SUGAR HILL MIXED-USE DEVELOPMENT

Re: Design Narrative of
Revisions for Historic
District Commission

RE: Sugar Hill Mixed Use Building Inset Panel Detail
119 Garfield Street, MI 48201
BLD# 2019-05307

1 SOUTH ELEVATION- GARFIELD STREET
1/8" = 1'-0"

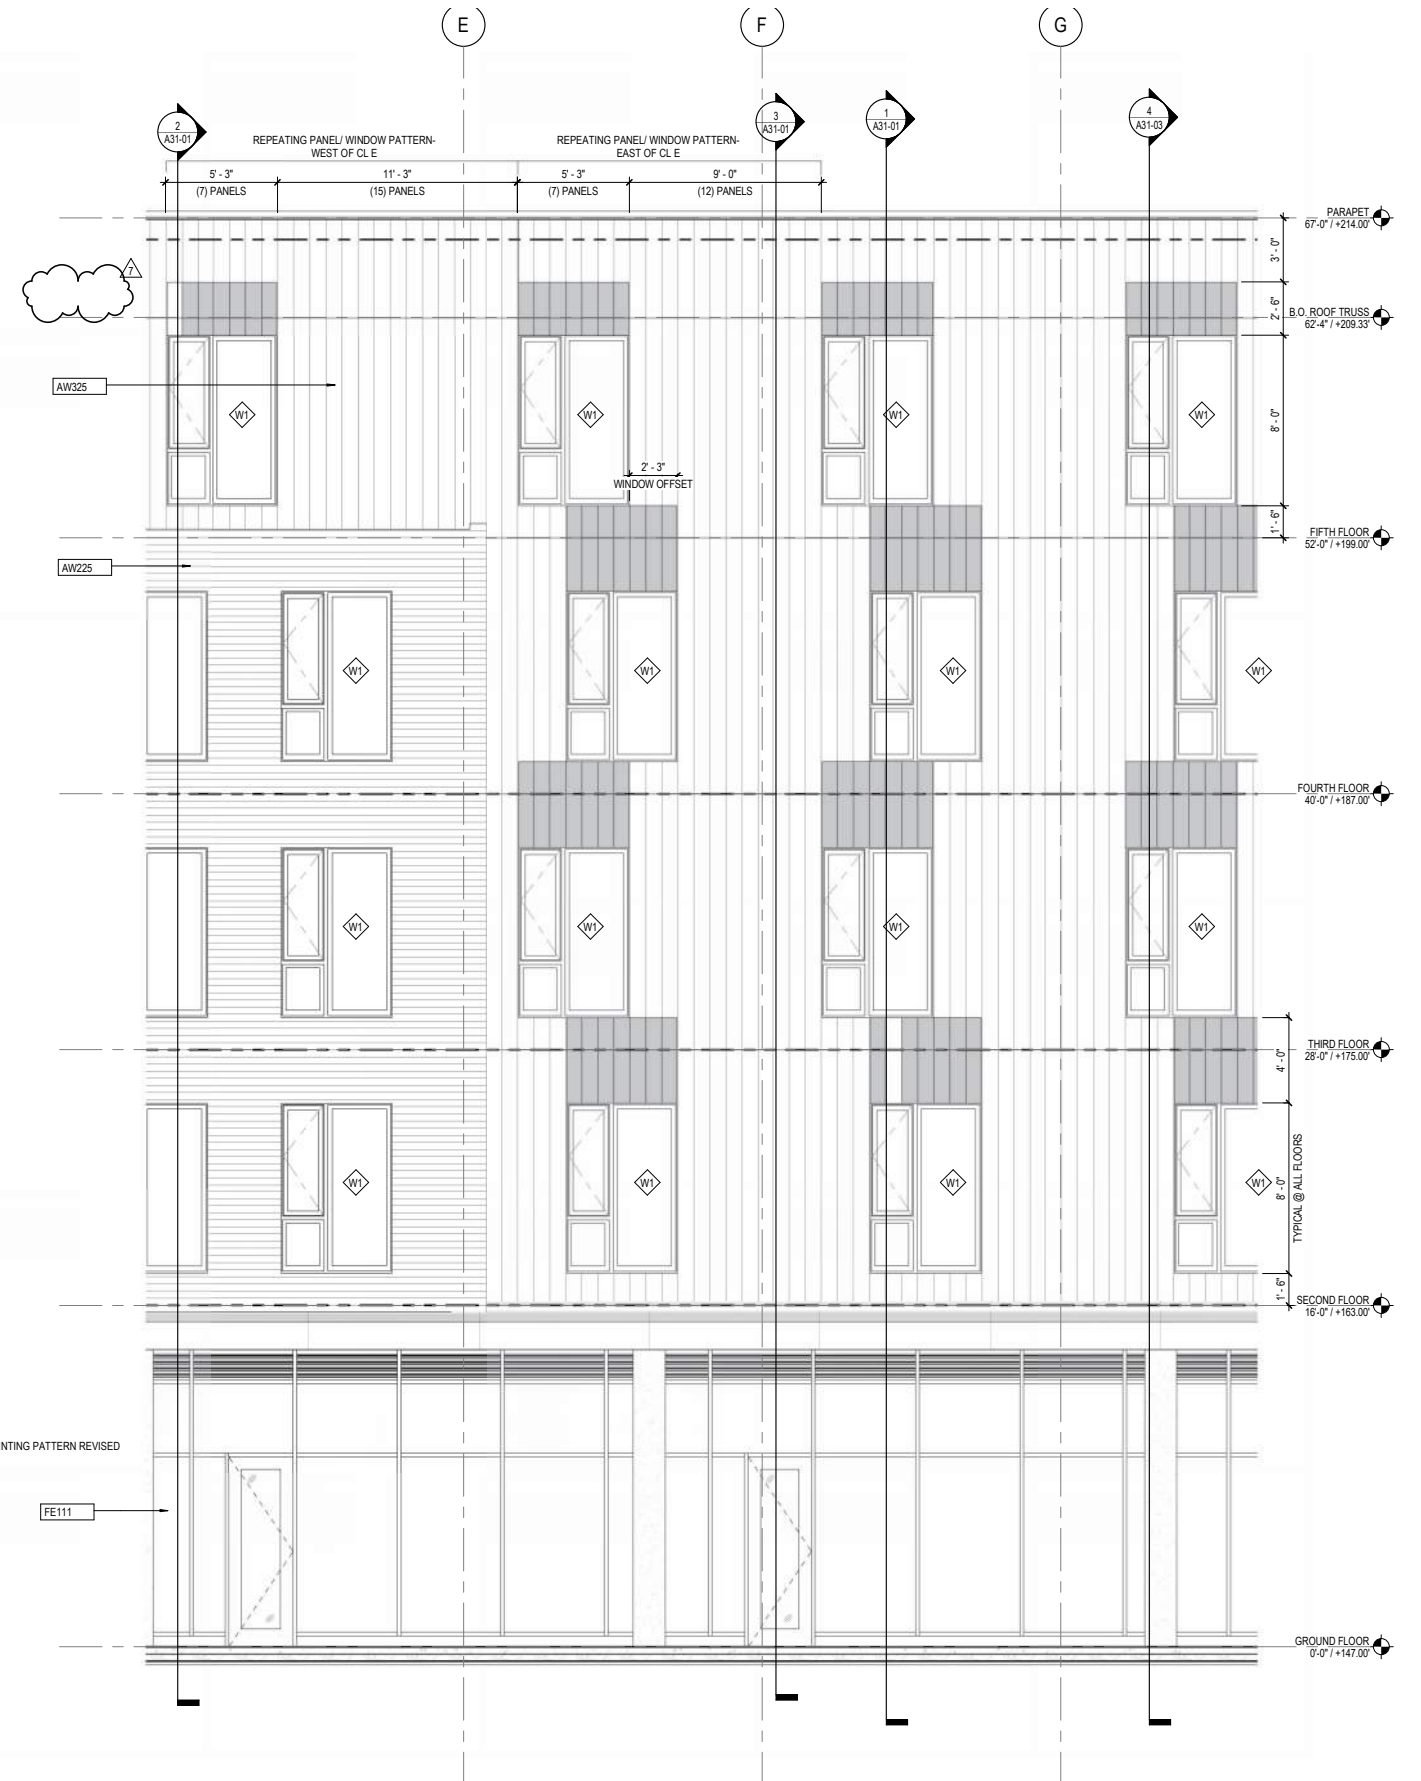
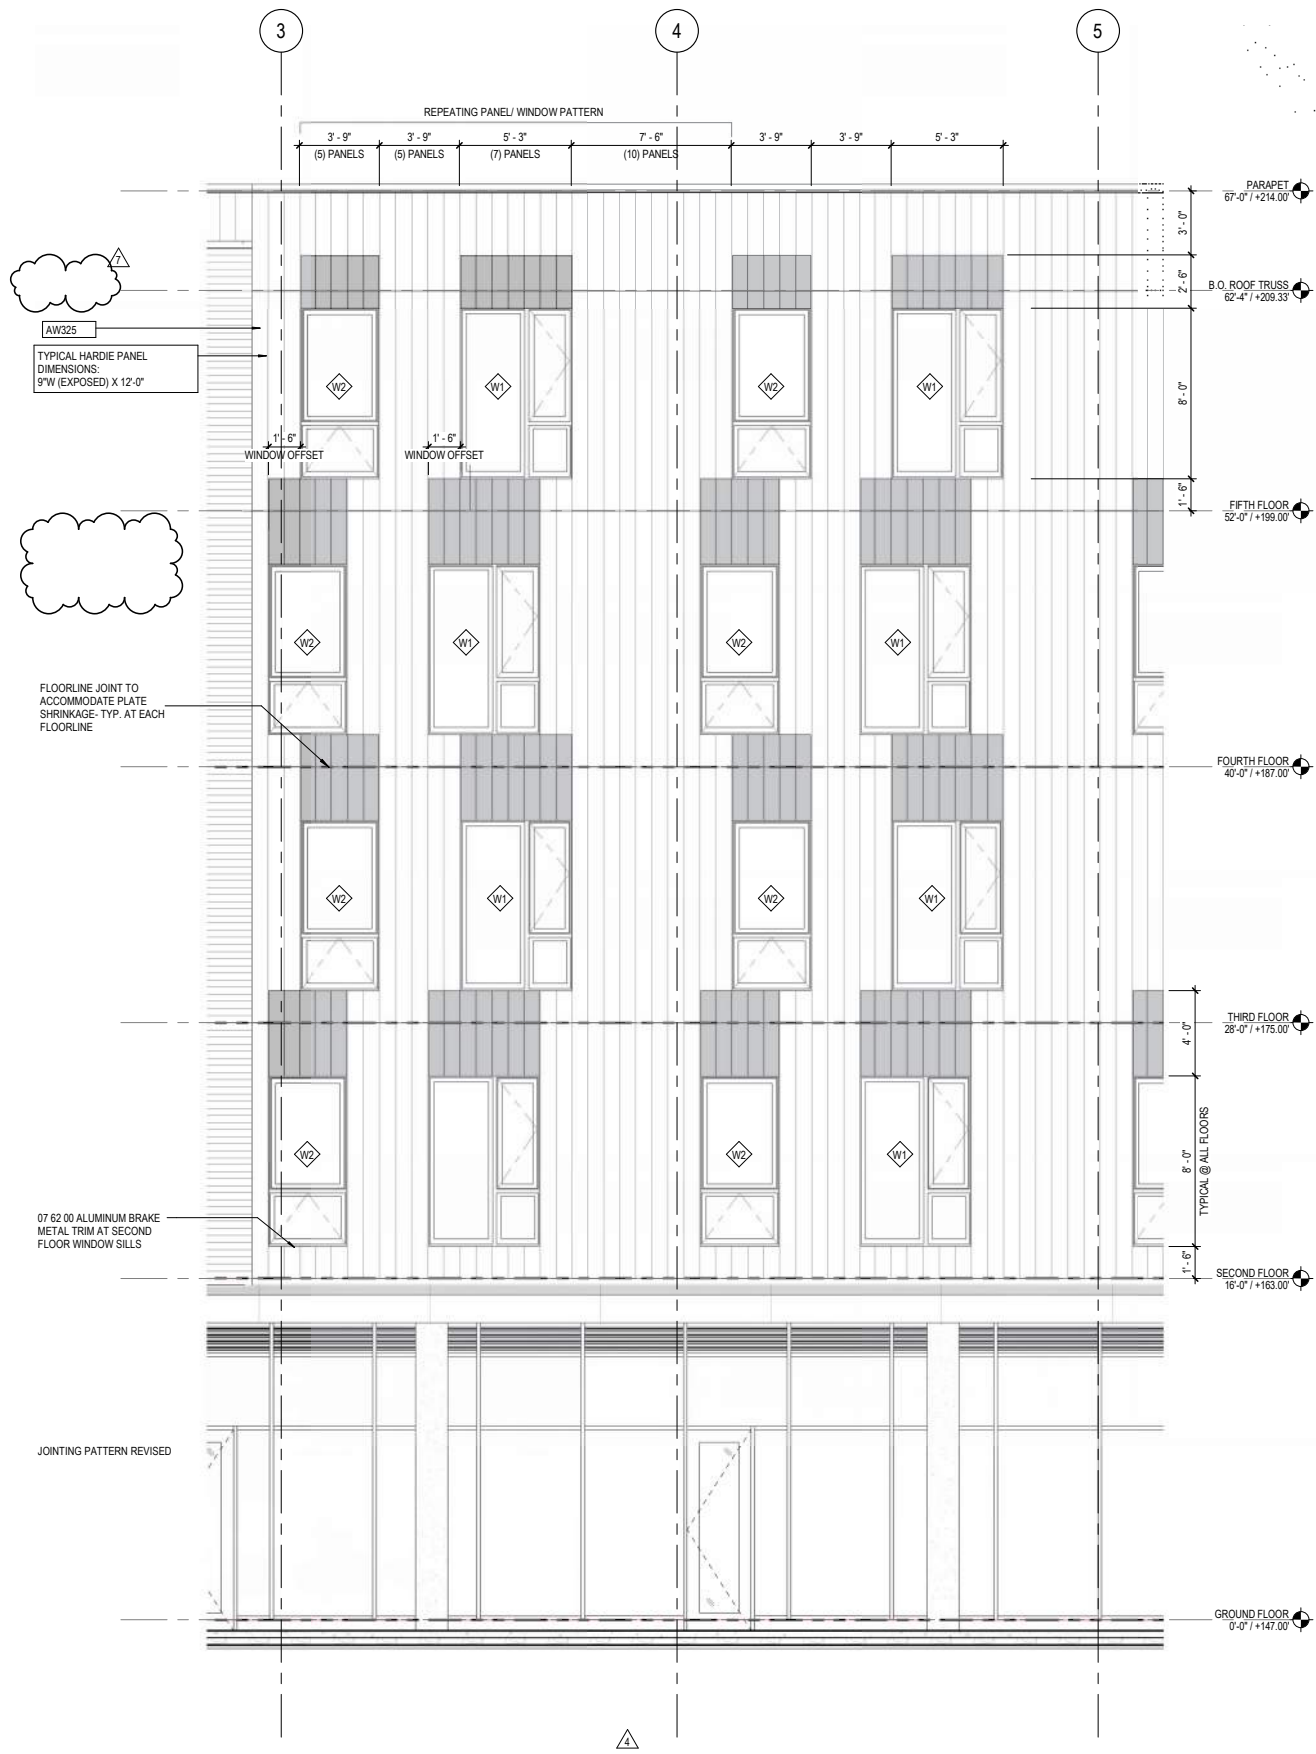
Elevation From Approved Permit Set (Permit received 3/3/2020)

Revised Elevation with Flush Panels

7 PLAN DETAIL-WINDOW JAMB
 1 1/2" = 1'-0"

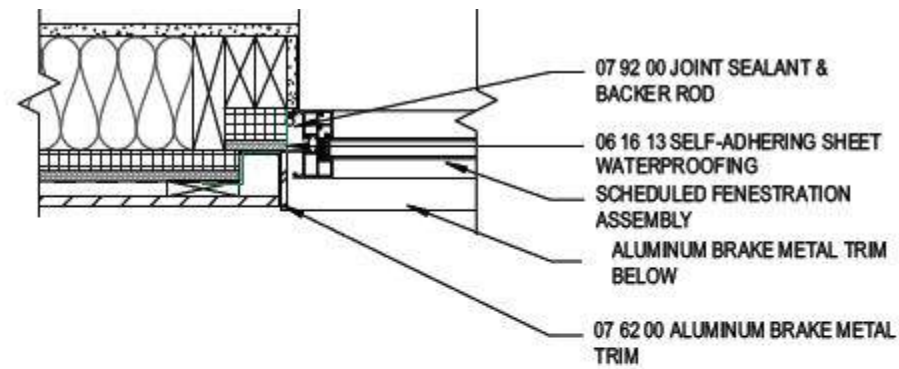
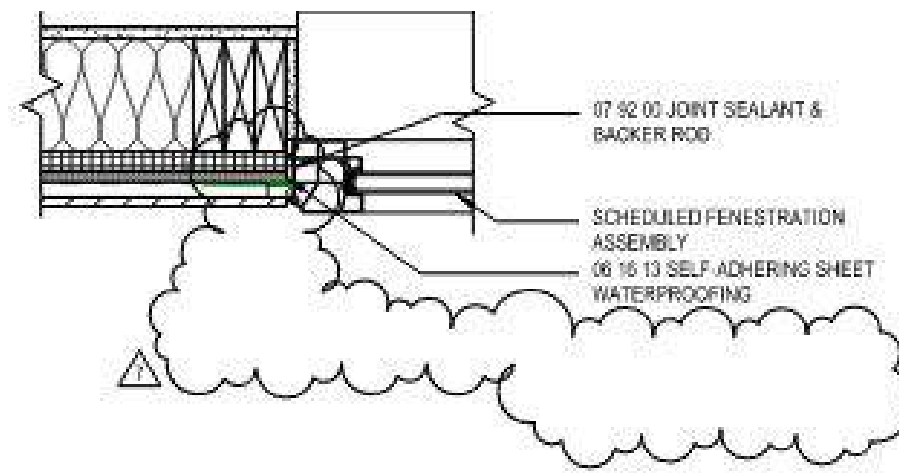
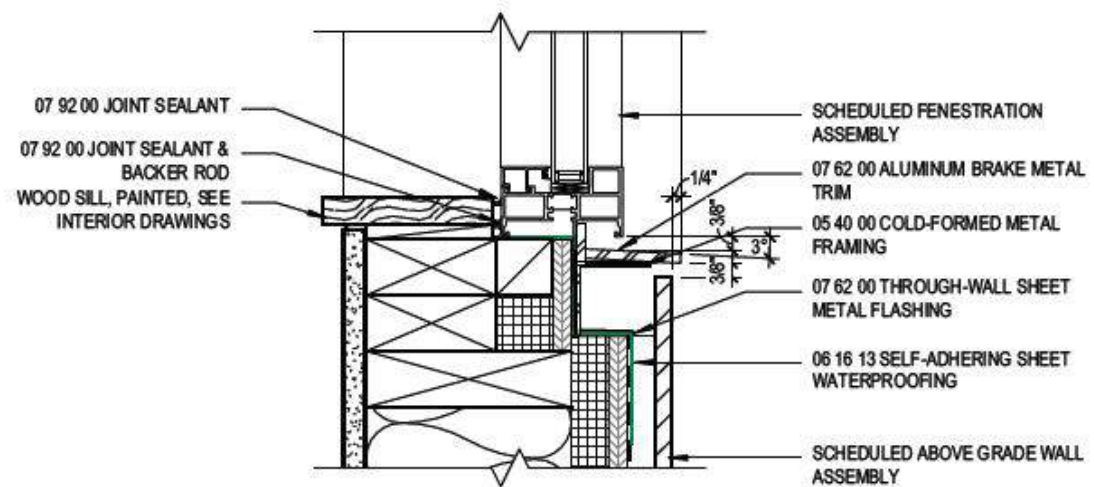
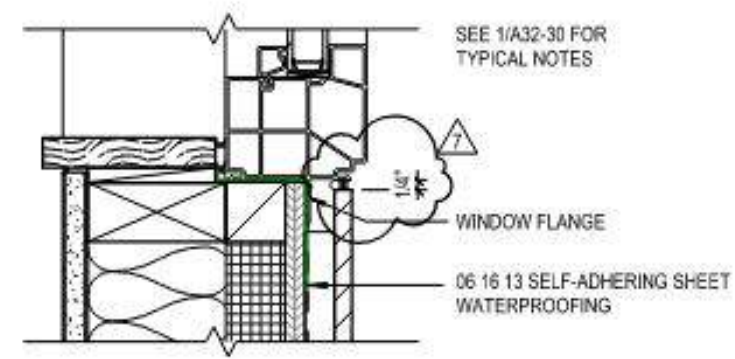
Inset Details From Approved Permit Set

Revised Inset Details
